RE: 280 Carlton Avenue

I reviewed the drawings and evaluated the site context. My comments and recommendations are as follows:

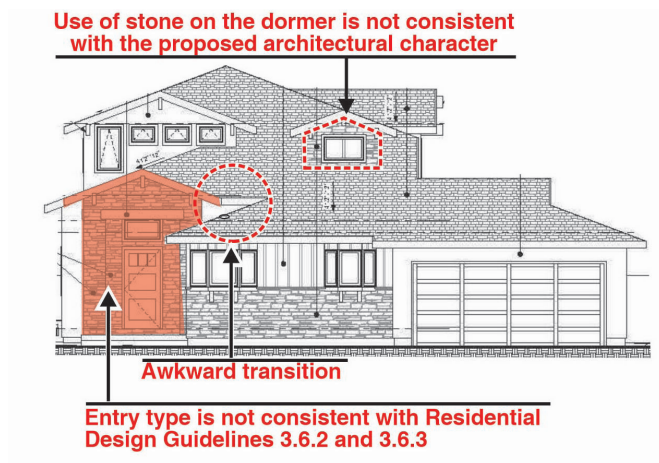
1. The proposed use of stone on the front dormer is heavy and not consistent with the architectural style.
2. The entry is not consistent with Residential Design Guidelines 3.6.2 and 3.6.3, and the roof transition at the entry is awkward.

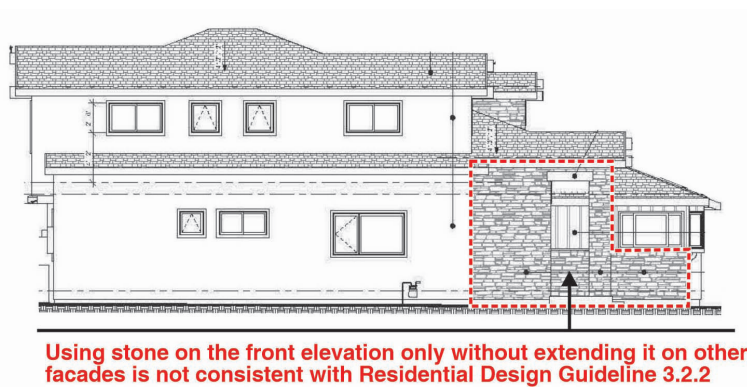
3. The use of stone on the front facade without carrying it consistently around the structure would not be consistent with Residential Design Guideline 3.2.2.

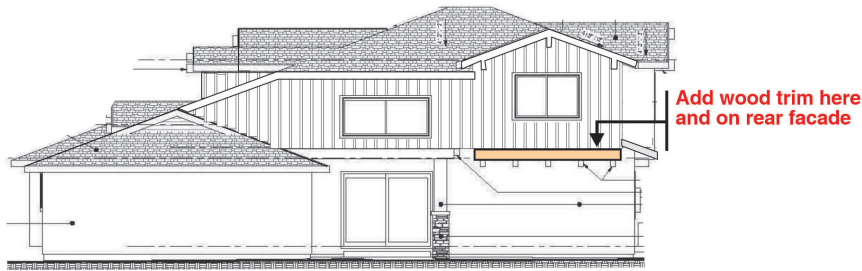
4. The corbel supports on the right side and rear facade projecting bay elements are good, but the detail is incomplete.

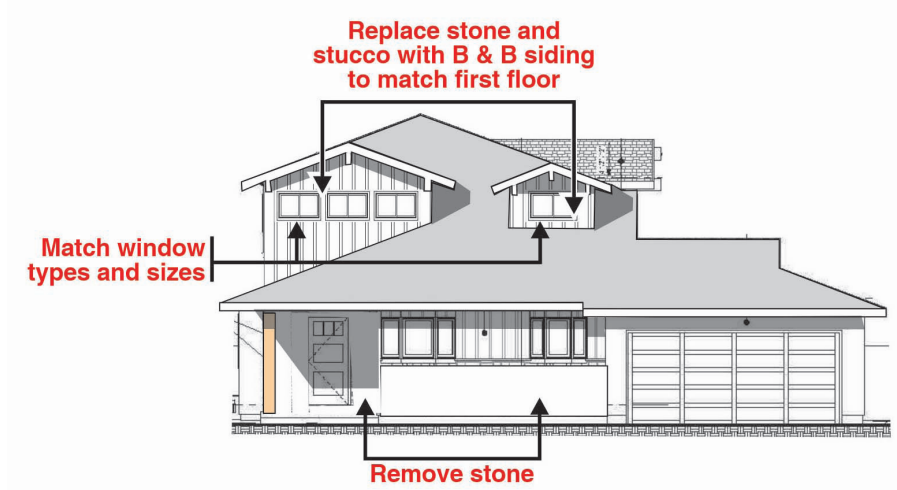
1. Remove all stone facing and replace with materials to match the rest of the first floor.
2. Add board and batten siding on all second floor walls to match the similar existing material on the existing front floor facade.

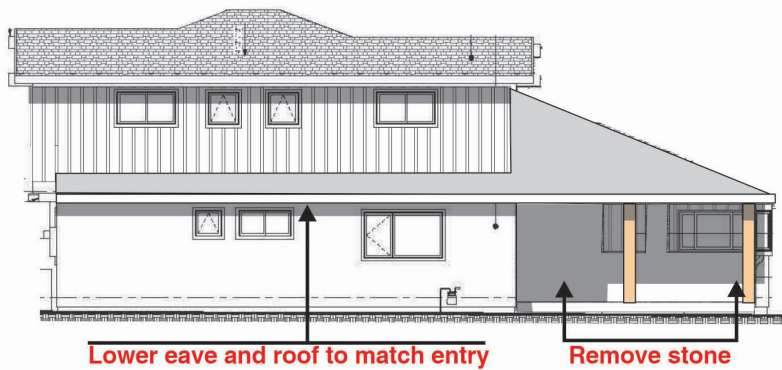
3. Replace the proposed tall entry form with an under the eave entry similar to the predominant entry type in the immediate neighborhood.

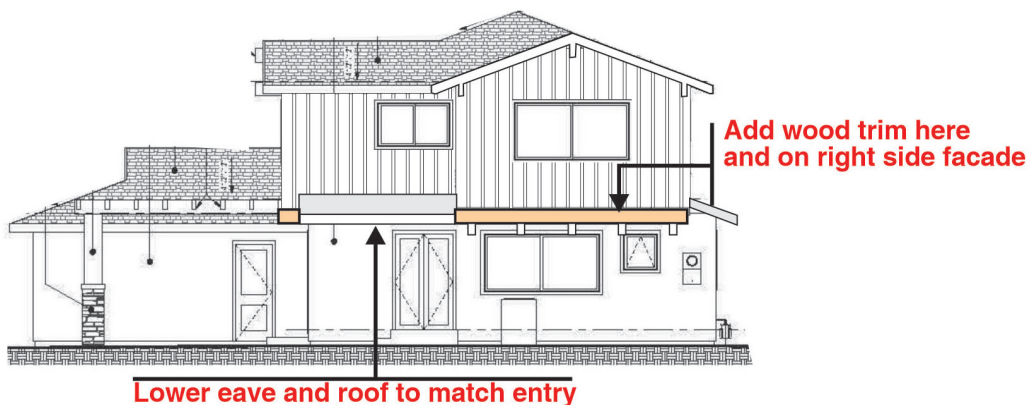
4. Lower applied roof segments on the left side and rear elevations to match the entry eave.
5. Add wood trim above the support corbels on both projecting pop out bays.

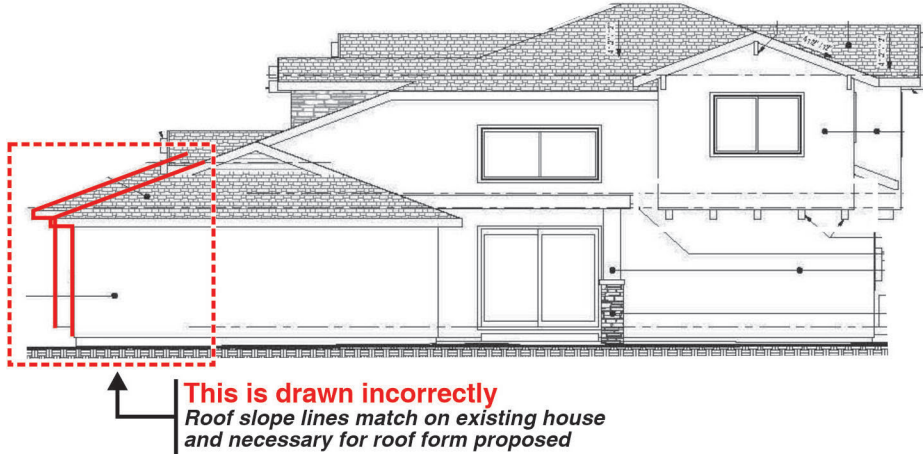
A. *The right side elevation is drawn incorrectly. The front of the bay windows align with the garage face and the roof surfaces align in a single flat plane.*

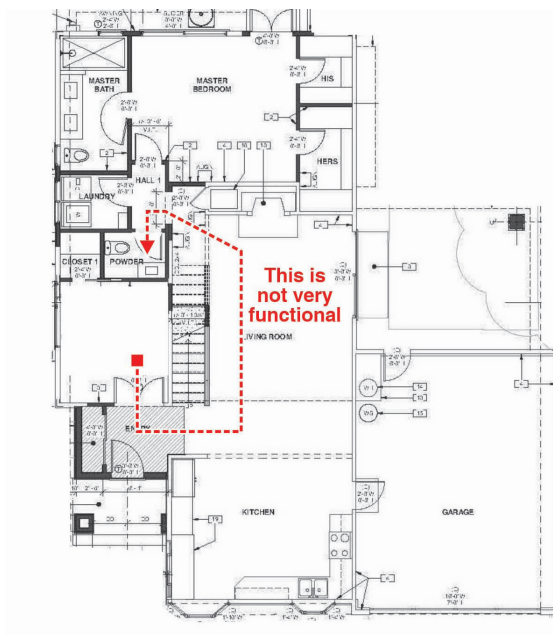
B. *The placement of the bedroom adjacent to the entry is functionally poor as it relates to its location relative to the nearest bathroom, and that bathroom is only a powder room with no tub or shower. Functionally, the room is more like a Den or Home Office.*

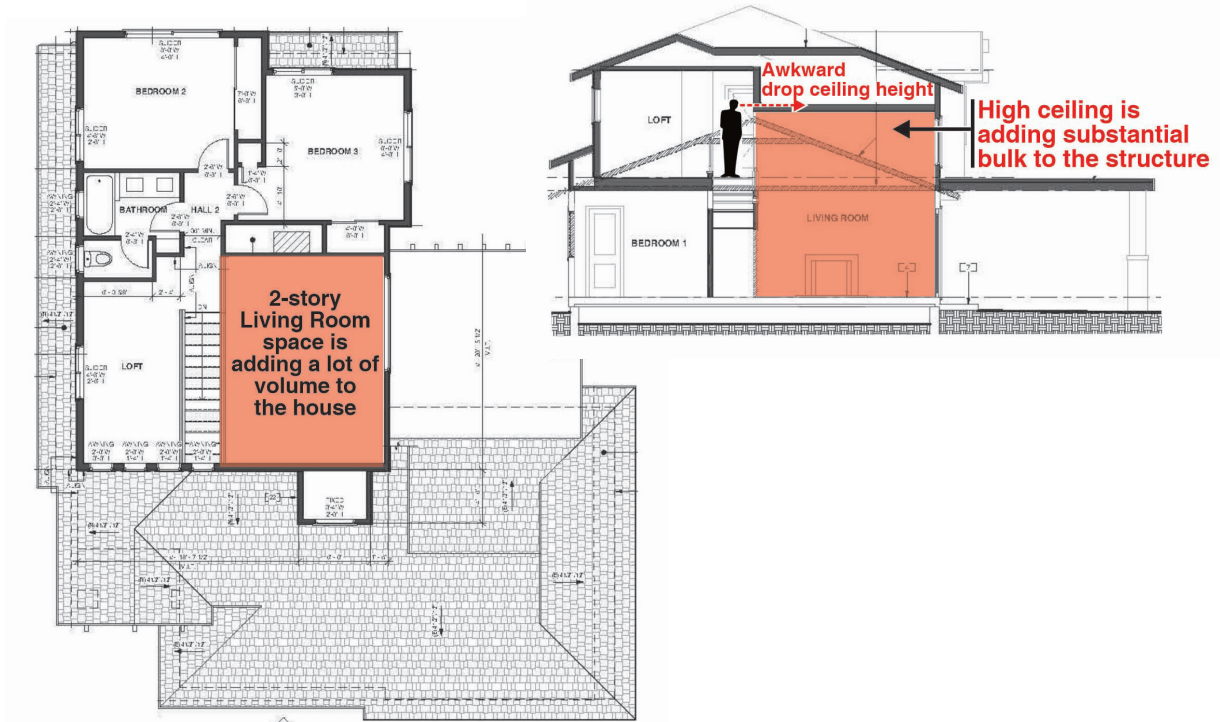
C. The very high ceiling over the Living Room is unusual for the Ranch Style of the house and will increase the visual bulk of the house.

D. The applicant should be aware that the drop ceiling over the Living Room is a bit too low relative to eye level on the second floor.
